The Corporation of the District of Saanich

Supplemental Report #2

To: Mayor and Council
From: Sharon Hvozanski, Director of Planning
Date: October 15, 2020
Subject: Subdivision, Rezoning and Development Variance Permit Application
 File: SUB00819; REZ00614; DVP00407 • 855 Falaise Crescent

Figure 1: Previous Site Plan from August 14, 2019 Report (from plans by Outline Home Design)

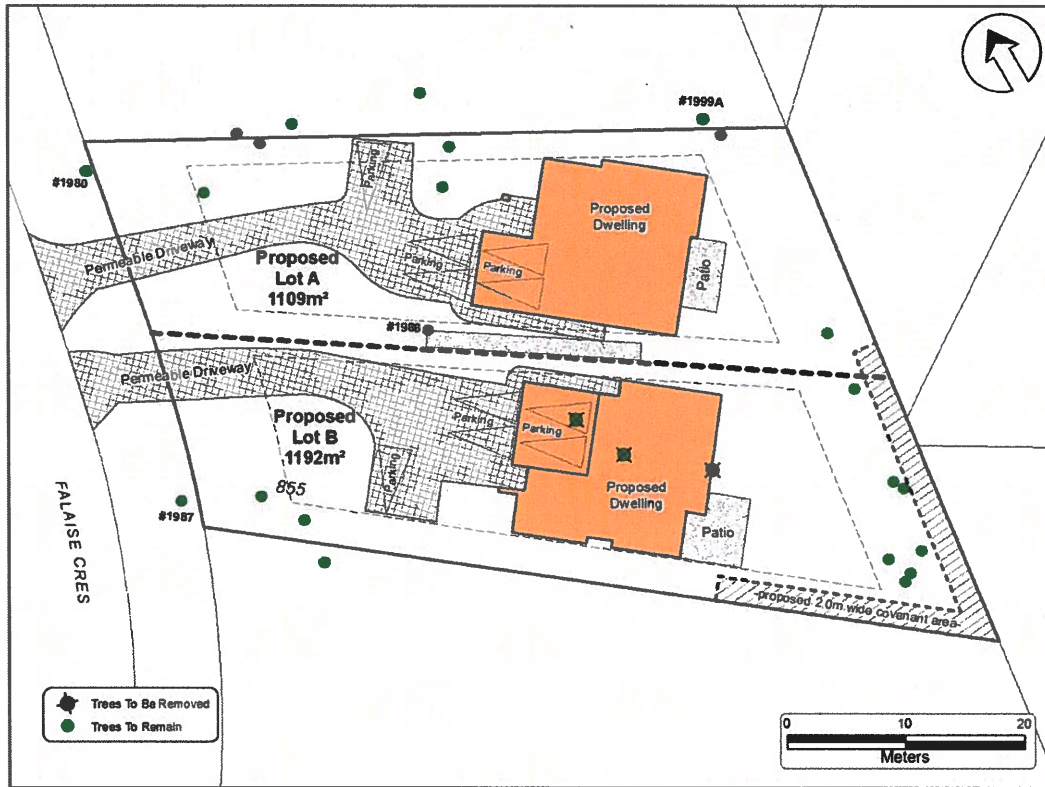
In order to retain the 88 cm Garry oak tree #1986, minor changes are proposed to the house locations and/or designs, and to the driveway locations from the May, 2019 proposal, described in the August 14, 2019 Supplemental Report from Planning (see Figure 1). The house on proposed Lot A has been rotated slightly on the site and shifted to the rear of the property. The proposed rear yard setback has been reduced by 1.9 m from 9.65 m to 7.75 m. The gross floor area of the proposed house has been reduced slightly from 291.25 m² to 288.47 m². Due to the repositioning of the house, the main floor elevation has increased by 0.3 m from 67.23 m geodetic to 67.53 m geodetic and the building height has increased by 0.17 m from 6.87 m to 7.04 m (see Figure 3).

Figure 2: Revised Site Plan dated June 11, 2020 (from plans by Outline Home Design)

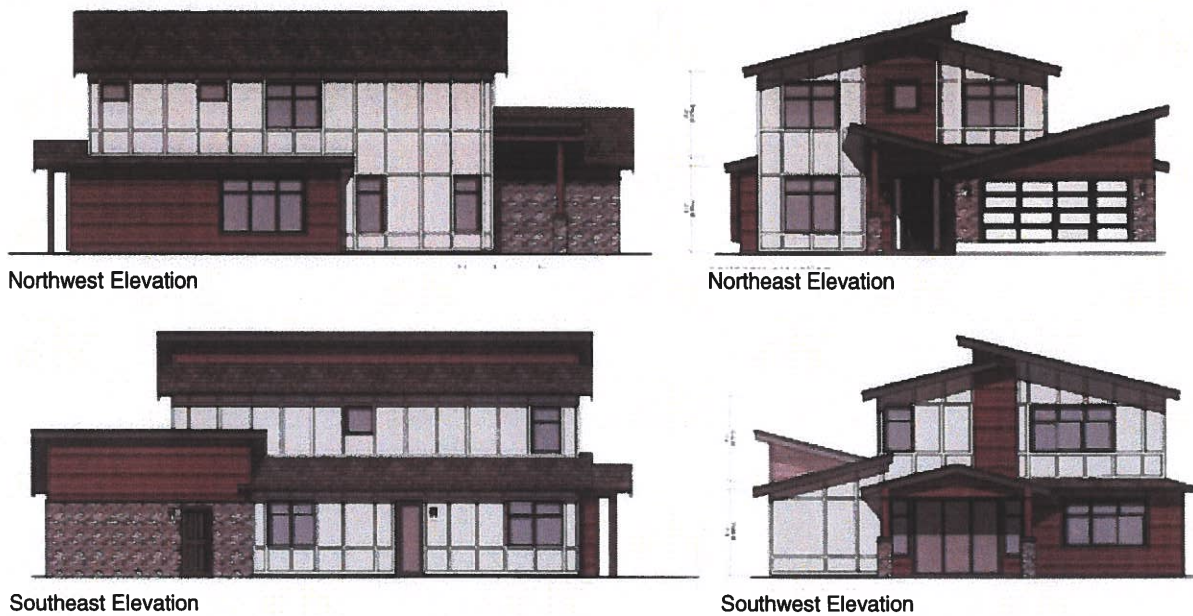
Driveway locations for both lots have been shifted slightly to reflect the changes to house location and provide less encroachment into the protected root zone for tree #1986. The driveway entrances have been moved closer together to minimize impacts on street parking and retained boulevard trees.
